Agenda Number: 06 Project Number: 1003275 Case #: 16EPC-40055 November 10, 2016

Staff Report

Request Site Development Plan for Building

The applicant is proposing to construct a 1,944 sf food service / retail building with a drive thru on the subject site.

SITE DEVELOPMENT PLAN FOR BUILDING PERMIT

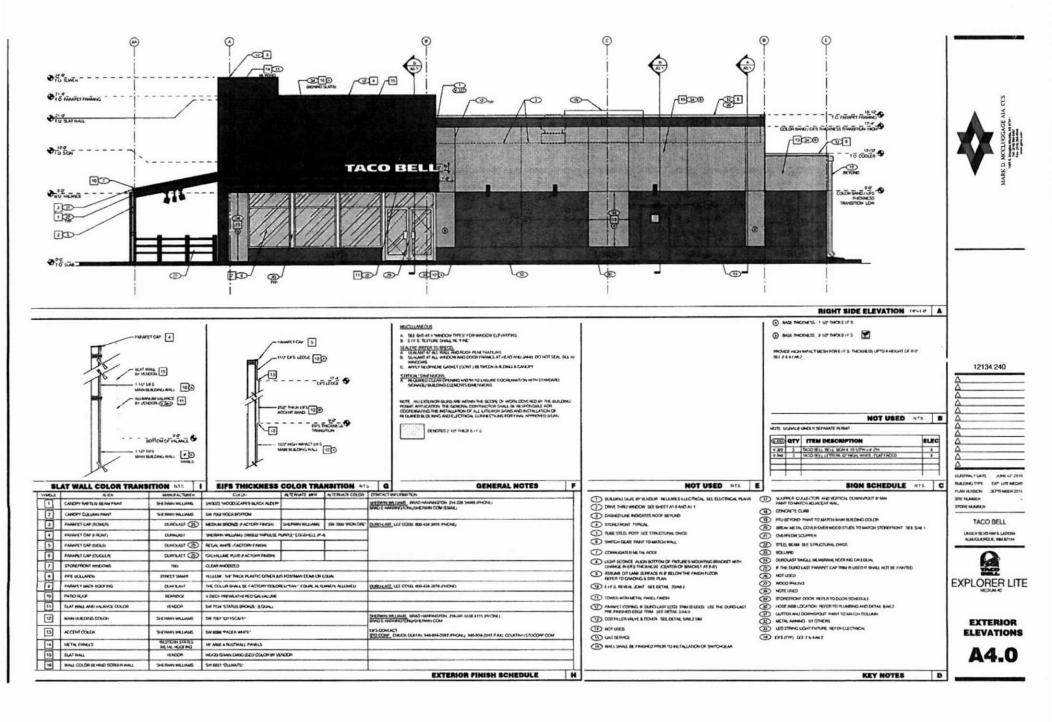
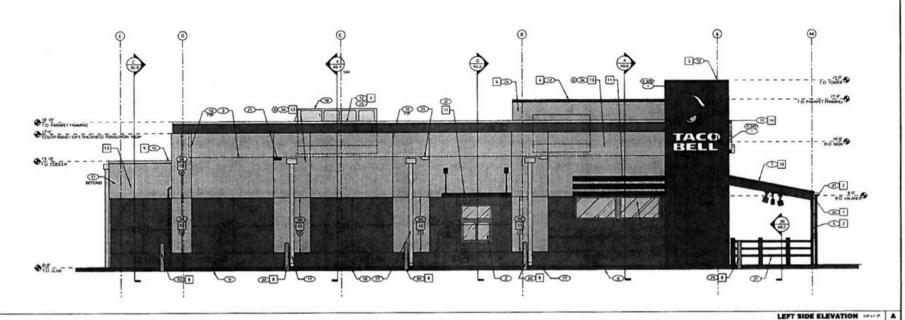
a. Northern entrance appears to have a diagonal curb at entrance, creating a hindrance for truck access. Please remove curb and keep entrance dimensions at 27.14'. Move proposed refuse enclosure 2' to the North for truck access. Do not plant anything next to proposed refuse enclosure that will create an overhang. All new/proposed refuse enclosures must be built to COA minimum spec. requirements, need complete/detailed spec. sheet for proposed refuse enclosure, including a sanitary drain.

- 1. Minimum drive thru lane width is 12 feet with a 25 foot minimum radius (inside edge) for all turns.
- 2. The ADA access aisles shall have the words "NO PARKING" in capital letters, each of which shall be at least one foot high and at least two inches wide, placed at the rear of the parking space so as to be close to where an adjacent vehicle's rear tire would be placed. (66-1-4.1.B NMSA 1978)
- The ADA accessible parking sign must have the required language per 66-7-352.4C NMSA 1978 "Violators Are Subject to a Fine and/or Towing." Please call out detail and location of HC signs.

- 4. Define the Radii on all curbs especially drive thru lane
- 5. Identify the right of way width, medians, curb cuts, street widths and street names.
- 6. Label correct site on zone map.
